ADDENDUM #3

Project	Nelson H.S. Renovations	Project No.	2323
Location	4181 New Street, Burlington, Ontario	Date of Issue	2024 05 31
Owner	The Halton District School Board	File	2323/7.1.3

This Addendum forms part of the Contract Documents and amends the original Drawings and Specifications, dated 2024 05 13, as noted below.

ROOF SECTION DETAILS

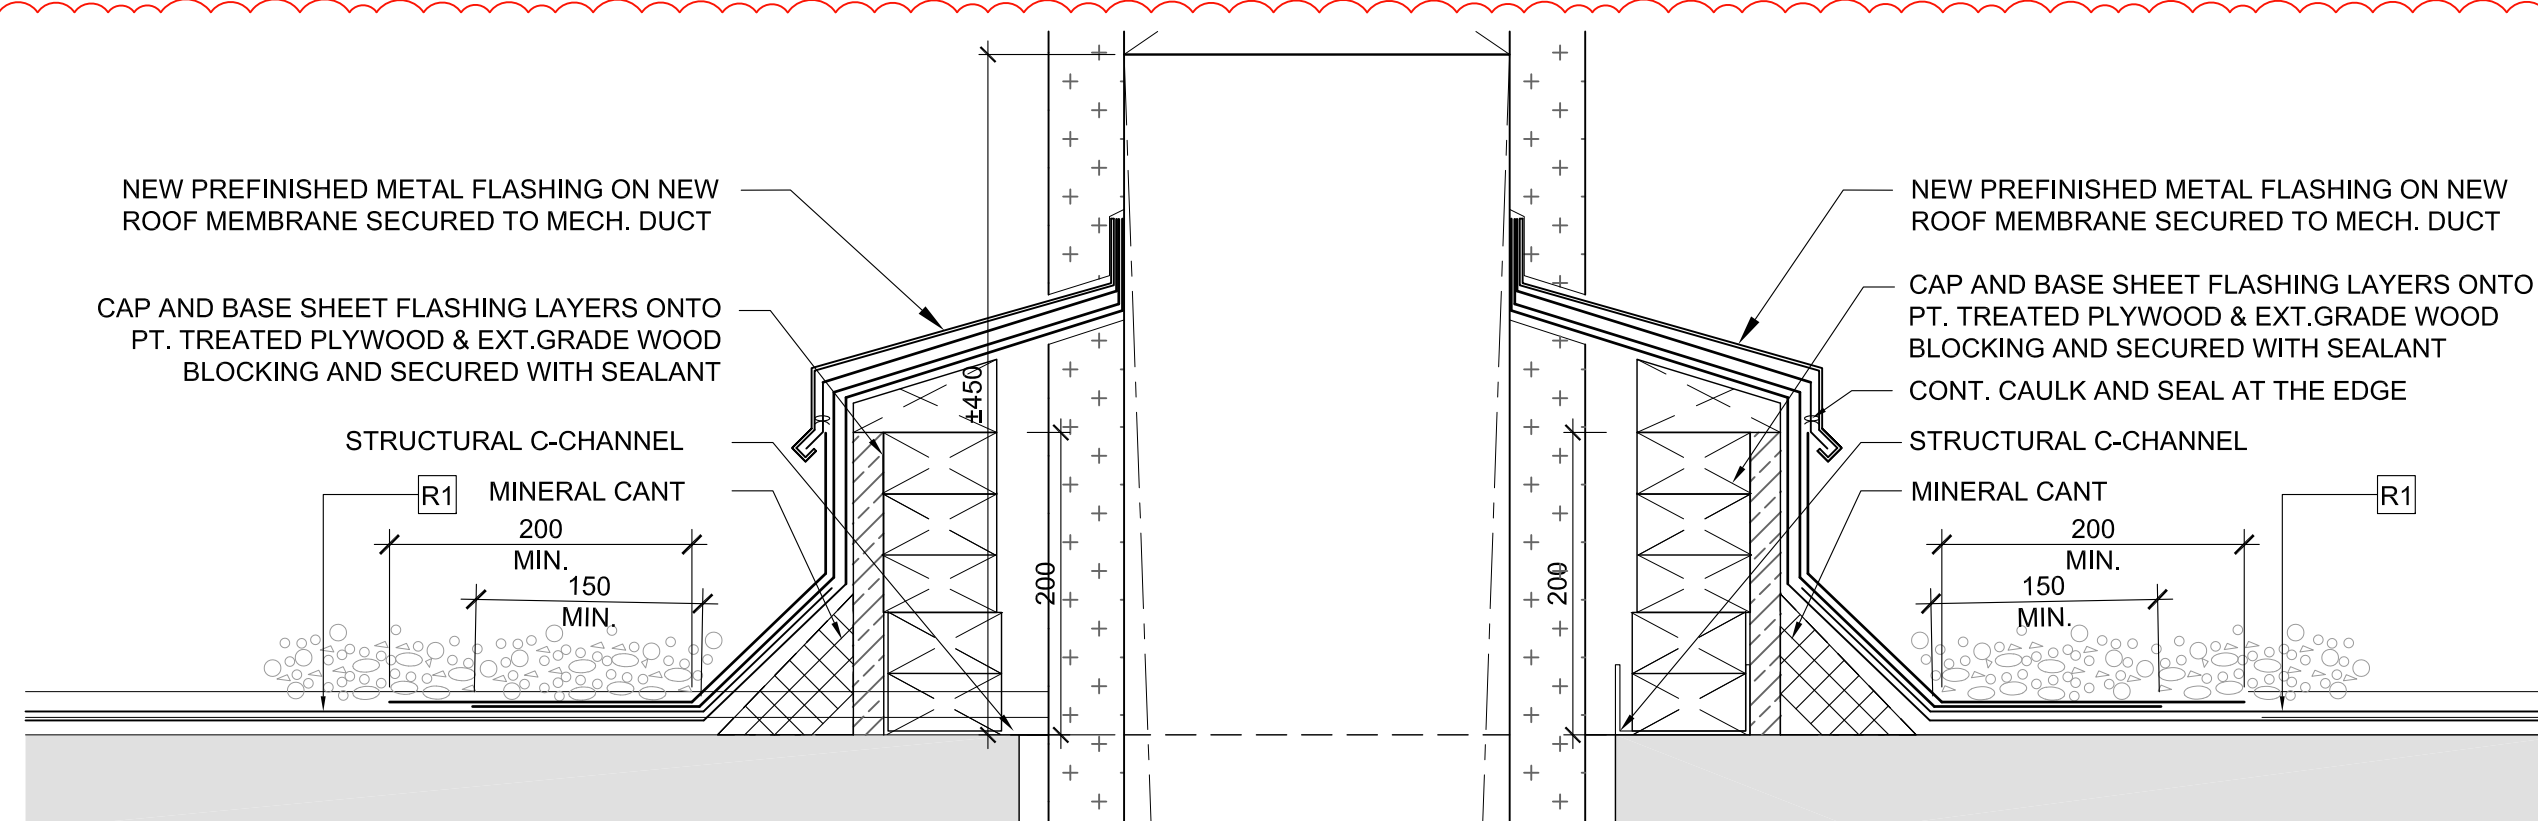
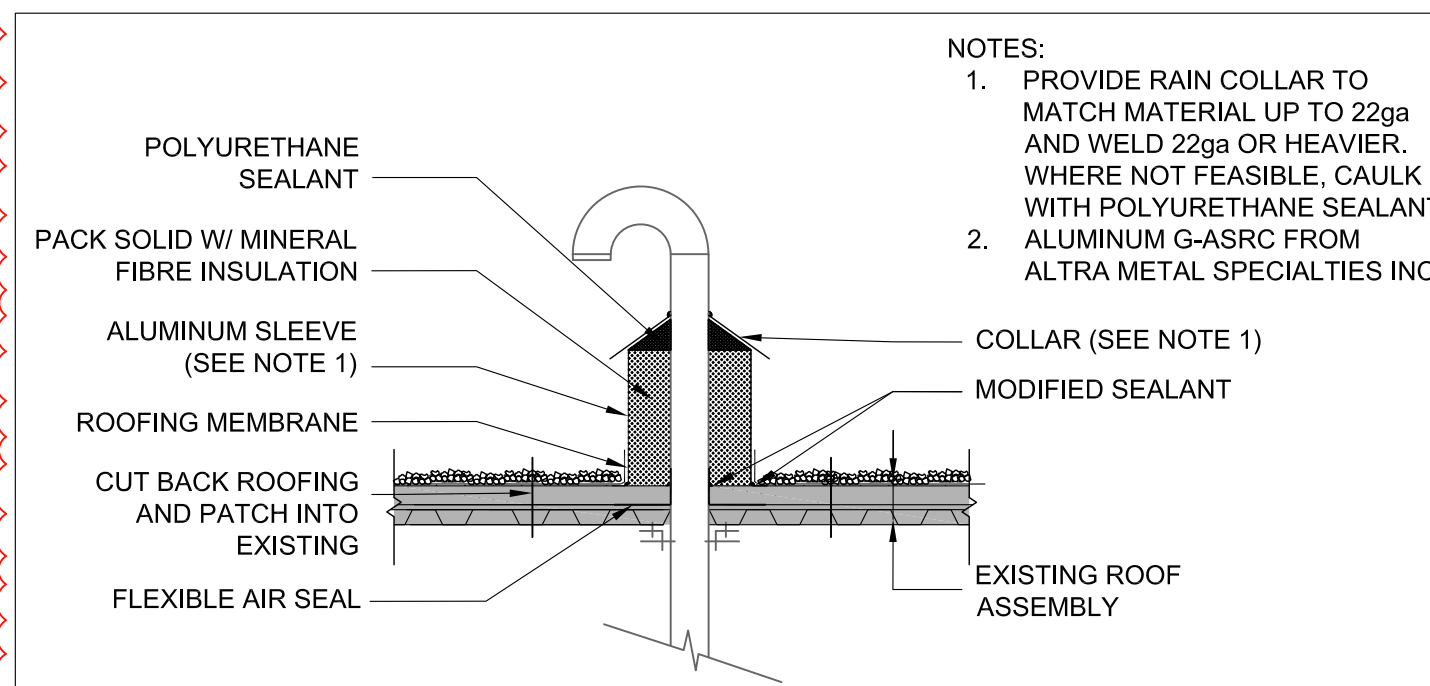
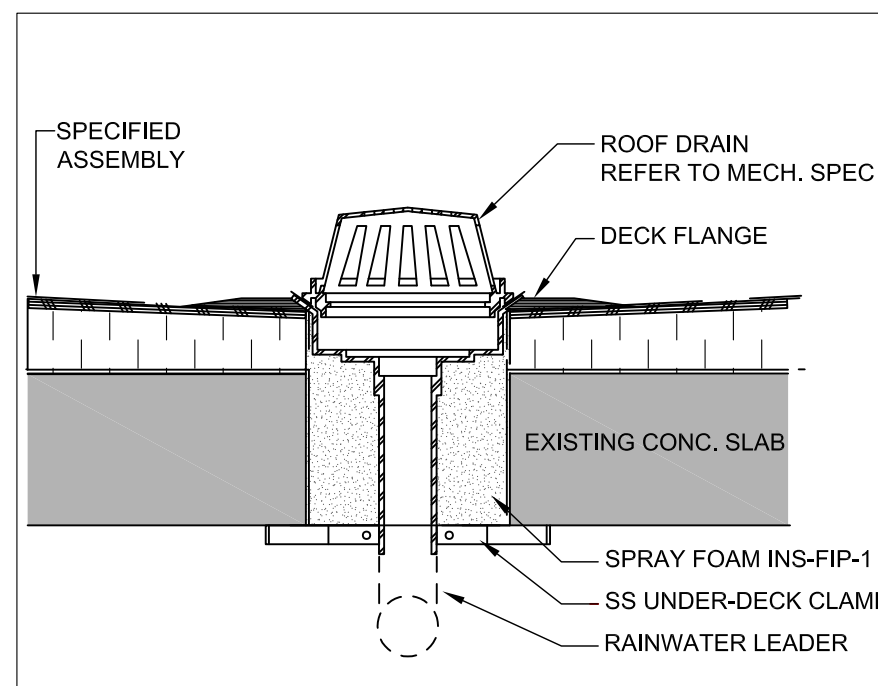
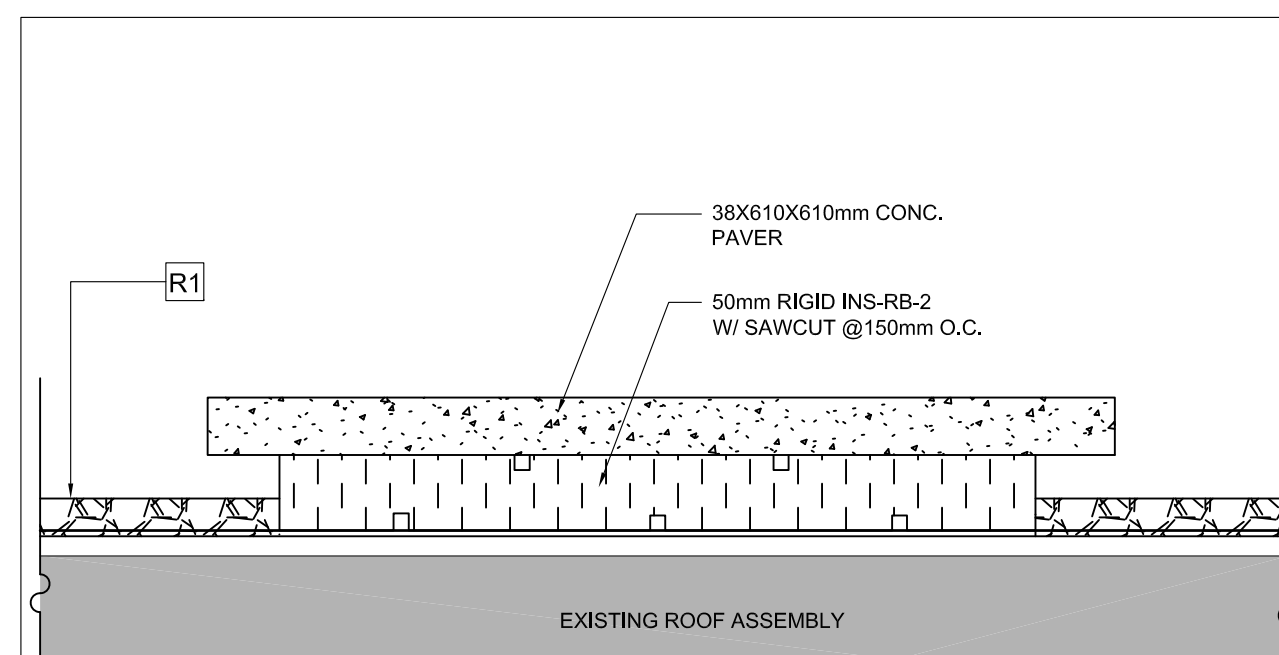
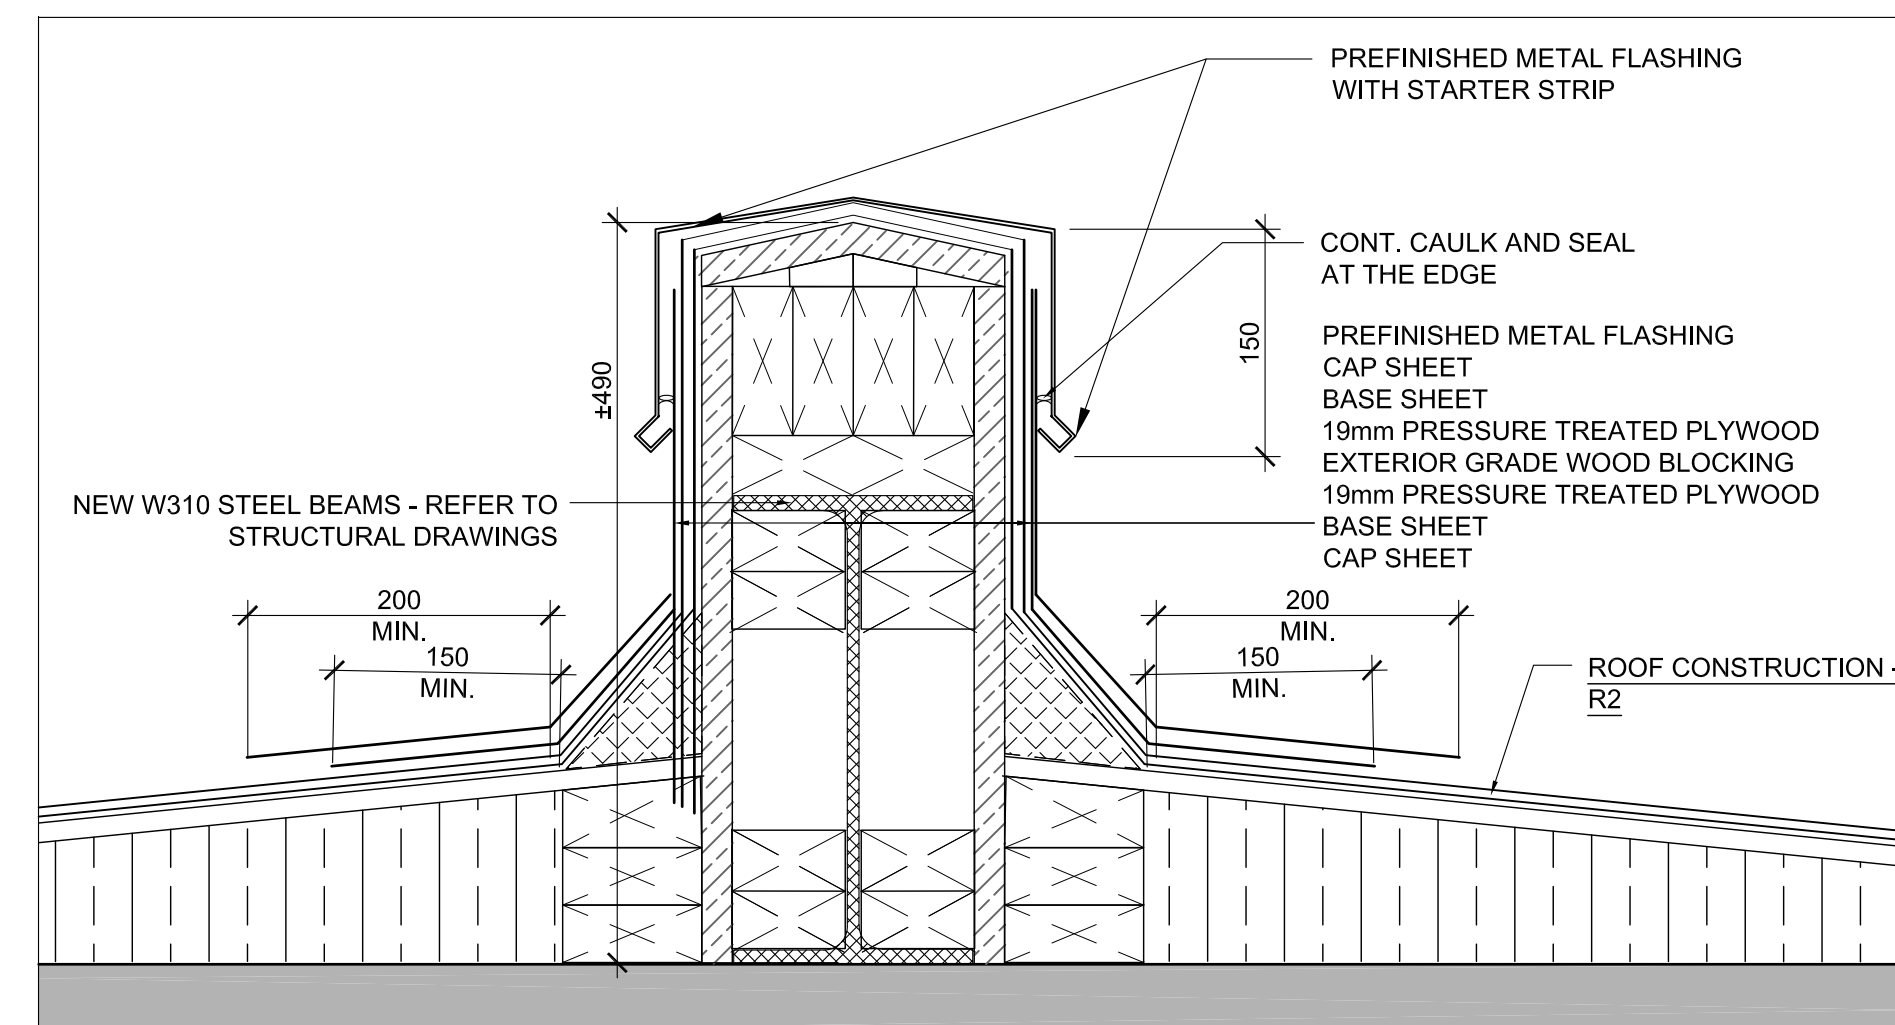
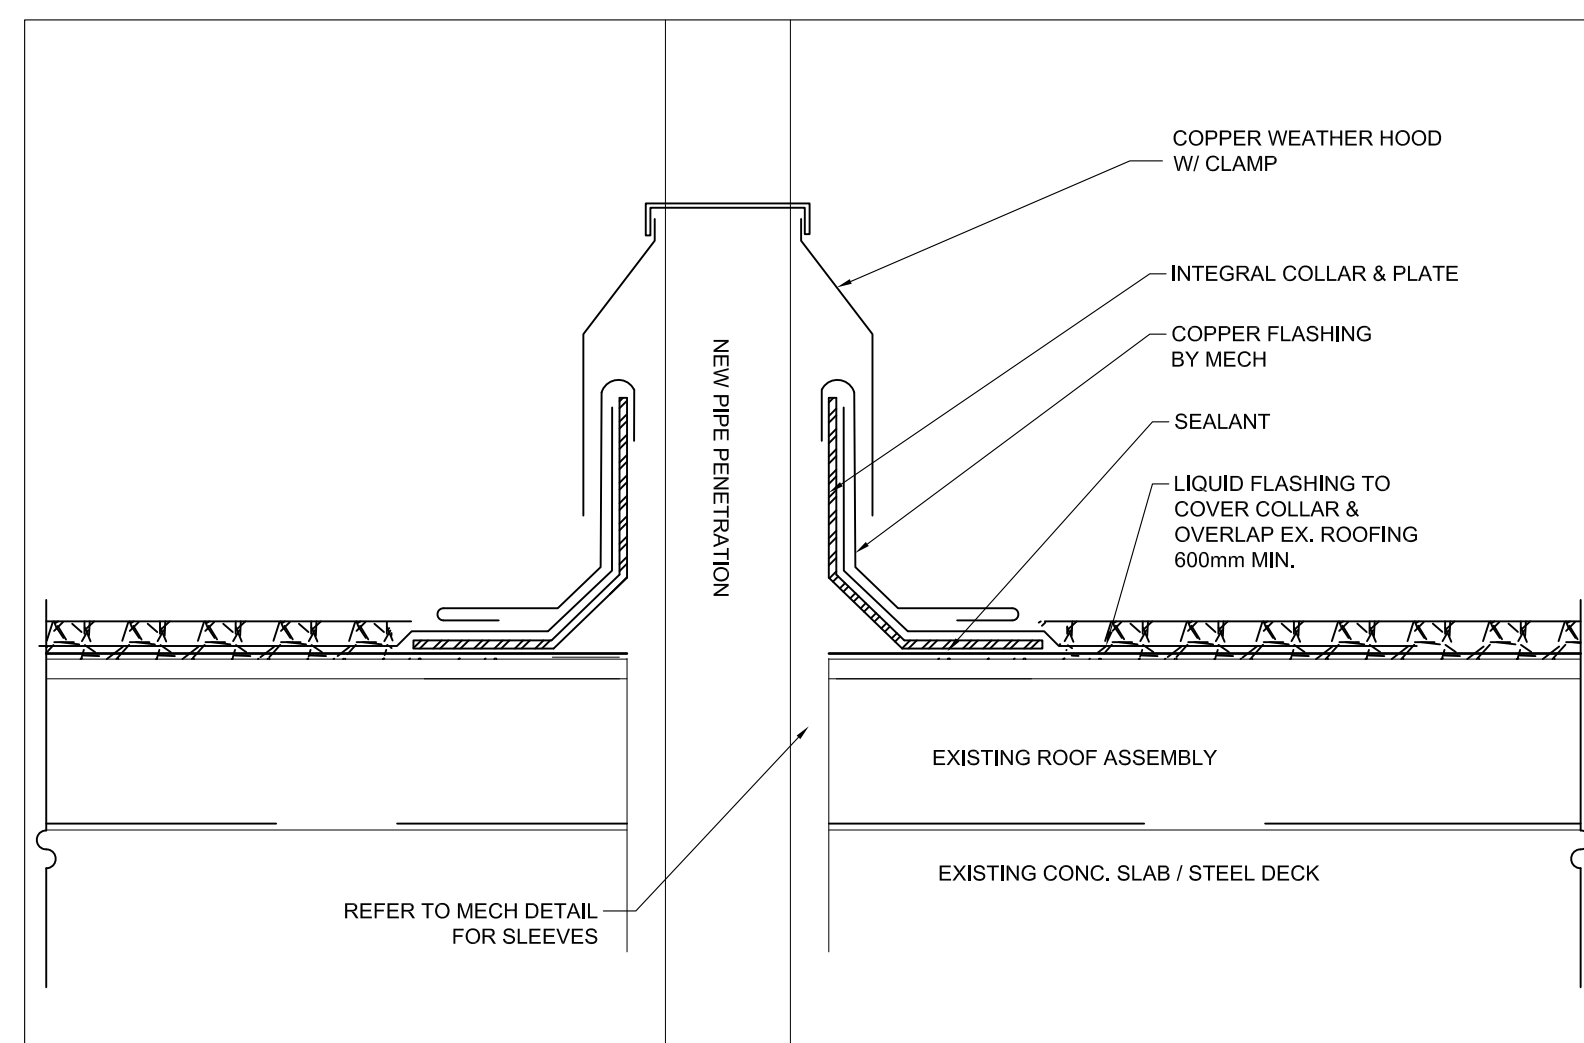
A3-12 DRAWING A502 ROOF SECTION DETAILS (reissued)

- .1 Replace drawing with re-issued drawing
- .2 Replace detail no. 1, 2, 4 and 5
- .3 Add detail no. 3, 6, 7, 8, 9 and 10

Q5 – Who provides the wood blocking required at roof details, parapets, curbs?

A5 – All wood blocking required for roofing as indicated on drawing A502 Roof
Section Details By SC07 ROOFING
